**SOLICITATION AMENDMENT**  
**MODIFICATION DE L'INVITATION**

<b>Title - Sujet</b> FURNITURE SYSTEMS & ENCLOSED OFFICE	
<b>Solicitation No. - N° de l'invitation</b> EP731-120478/A	<b>Amendment No. - N° modif.</b> 003
<b>Client Reference No. - N° de référence du client</b> 20120478	<b>Date</b> 2012-03-21
<b>GETS Reference No. - N° de référence de SEAG</b> PW-\$SPQ-419-57995	
<b>File No. - N° de dossier</b> pq419.EP731-120478	<b>CCC No./N° CCC - FMS No./N° VME</b>
<b>Solicitation Closes - L'invitation prend fin</b> <b>at - à 02:00 PM</b> <b>on - le 2012-04-13</b>	<b>Time Zone</b> <b>Fuseau horaire</b> Eastern Daylight Saving Time EDT
<b>F.O.B. - F.A.B.</b> <b>Plant-Usine:</b> <input type="checkbox"/> <b>Destination:</b> <input checked="" type="checkbox"/> <b>Other-Autre:</b> <input type="checkbox"/>	
<b>Address Enquiries to: - Adresser toutes questions à:</b> Gauthier, Claire	<b>Buyer Id - Id de l'acheteur</b> pq419
<b>Telephone No. - N° de téléphone</b> (819) 956-0938 ( )	<b>FAX No. - N° de FAX</b> (819) 956-5706

**This amendment is raised to address questions raised during the solicitation period and to extend the solicitation closing date.**

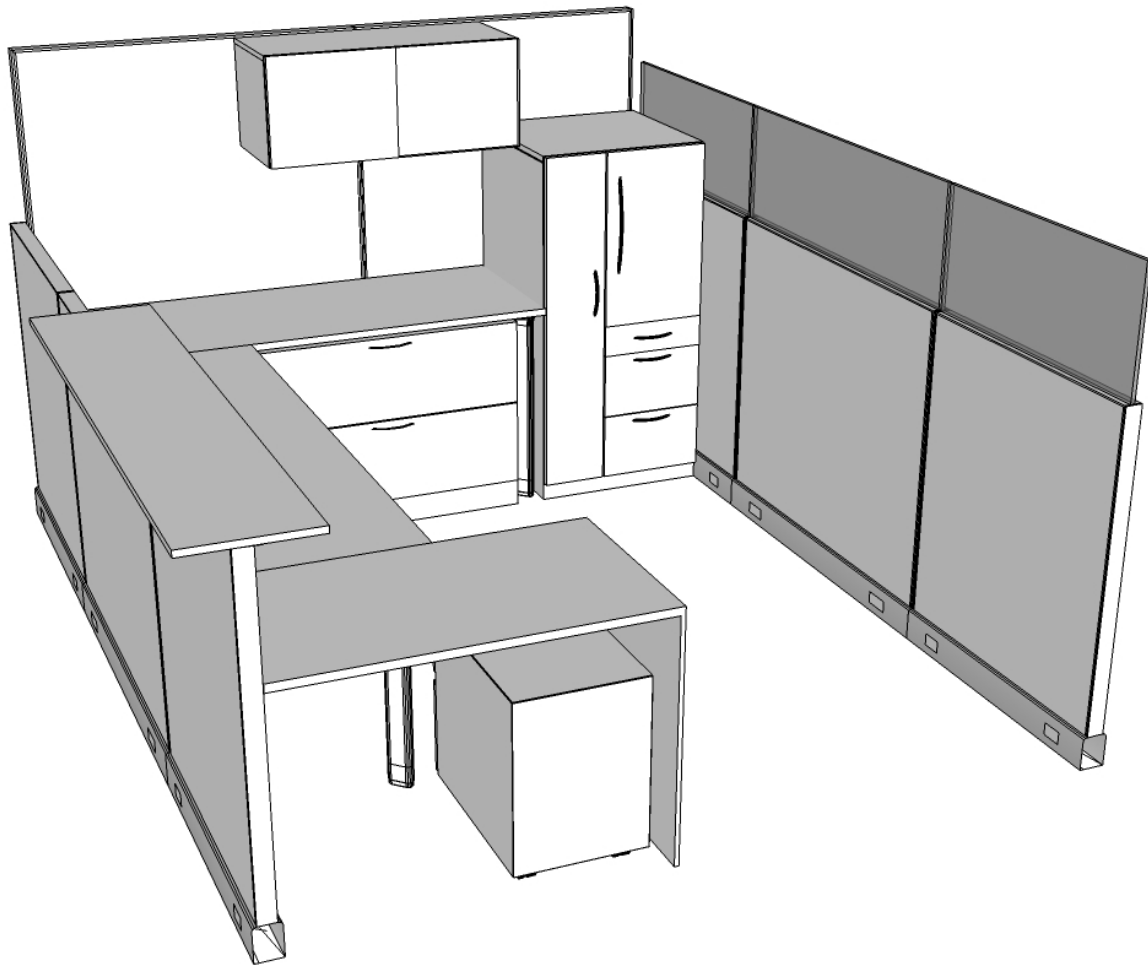
Q86. On the floor plan, the 3rd floor drawing includes panels along the window, labeled at 30"h with power (see below). However, on all the other floors, and on typical #2, the panels along the window are without power and without elements. Please confirm that the 3rd floor panels along the windows are "30"h without power (no elements)", as per typical #2.

A86. All the panels along the windows including the 3rd floor are without power and without elements

## Workstation 5 ( 6.96m2 )

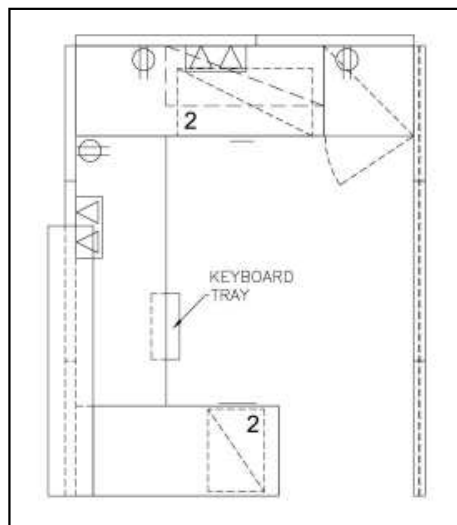
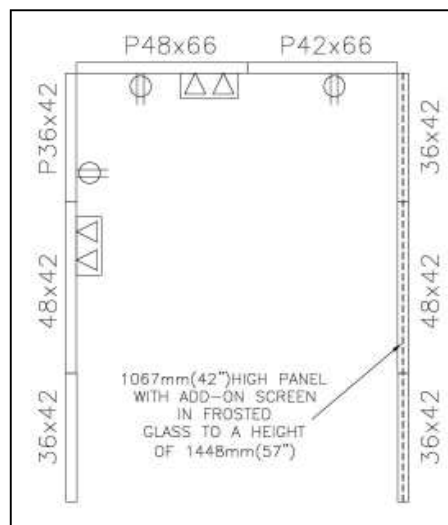
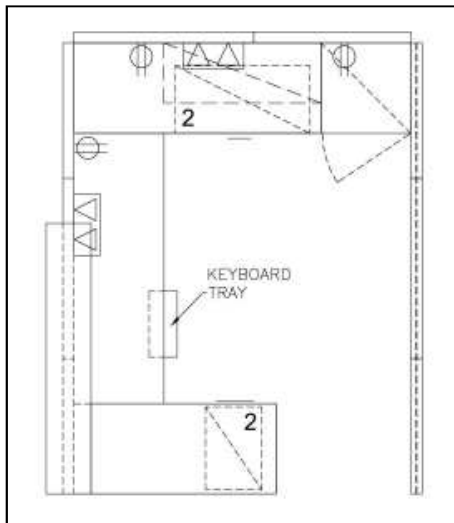
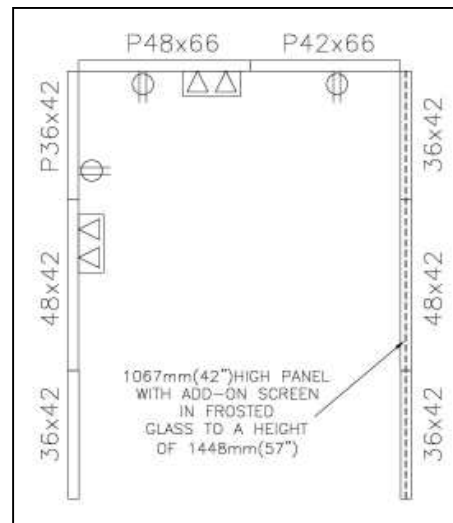
Q52. Please provide some clarification on workstation #5 a) Please provide more details of panel mounted work surface. The 3D drawing shows a modesty panel off a panel hung surface, also this surface would need to attach to the end of the panel where the leg of your height adjustable table is interfering with the support of the unit. b) Please clarify the dimension + or – of the freestanding tapered work surface. What

is the depth of the opposing end of the 24 inches c) The 42 x 24 height adjustable surface will not accommodate a 36" lateral file due to the leg of the table. The dimension left between the two legs is 27".

Q61. 5.4.6. indicates that work surfaces would be identified on the typical as either Freestanding or Panel Hung, however Workstation Typical #5, both Freestanding and Panel Hung surfaces of the same size are listed but not differentiated on the drawing. Please confirm which work surface is panel hung and which one is freestanding.

Q77. Workstation Typical #5 – The Freestanding supports for the Tapered work surface will interfere with the panel mounted work surface set below it at 20"high; To maintain the surface area and height adjustability requirements of the work surfaces, can this typical be revised to include the panel hung work surface at 29" high and the Tapered and adjacent rectangular work surface sizes adjusted.

A52. Please delete workstation data sheet #5 and replace revised workstation data sheet #5 dated February 23, 2012.

A61. Please see attached Revised workstation 5 Dated February 23 2012.

A77. This is not the current workstation typical #5. Please refer to Data Sheet workstation 5 revised Feb 23 2012.
